Kirby Morgan Dive Systems, Inc.®

New Product Bulletin #2 Of 2004 January 12, 2004

Subject: New Tri-Valve™ Exhaust Kit

Products Affected: All Kirby Morgan® SuperLite™ Helmets and Band Masks®

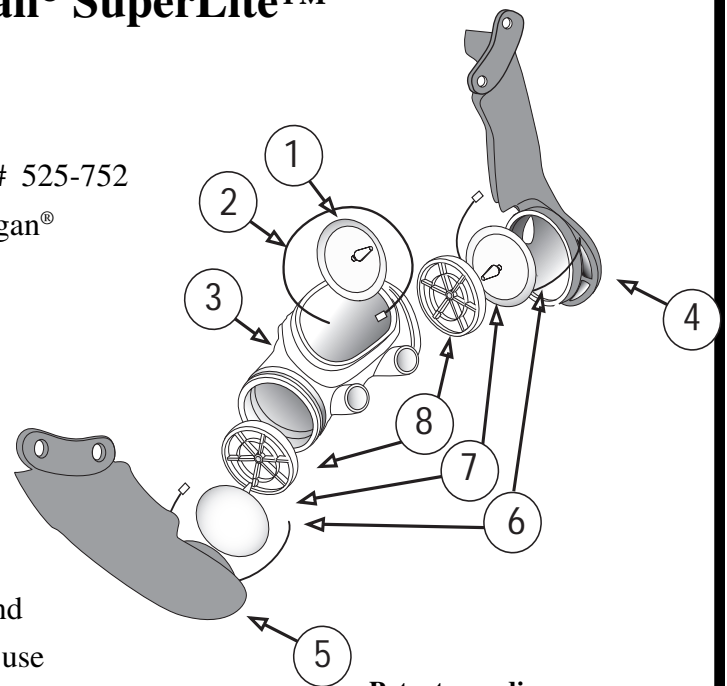
The patents pending **Tri-Valve™** Exhaust Kit, Part # 525-752 & 525-755 (SL 27 only), retrofits to all previous Kirby Morgan® SuperLite™ Helmets and KMB Band Masks®. It has been tested and certified to meet or exceed all requirements for all governing testing agencies.

The new **Tri-Valve™** Exhaust System has less breathing resistance than the older single valve exhaust while providing an extremely dry hat. The entire exhaust system and Whiskers™ are made of chemically resistant materials for use in polluted water and is quite robust.

The **Tri-Valve™** is a very important advance in design. It provides a separate exhaust chamber after the exhaust gases exit the regulator. This traps any small drips of water within this chamber and ejects them, keeping the interior of the regulator very dry and isolated from the surrounding water. The unique, (patent pending), exterior channeling creates a relative low-pressure area on the exterior of the exhaust valve. This low-pressure area lowers the work of breathing and adds another barrier to water leaking in.
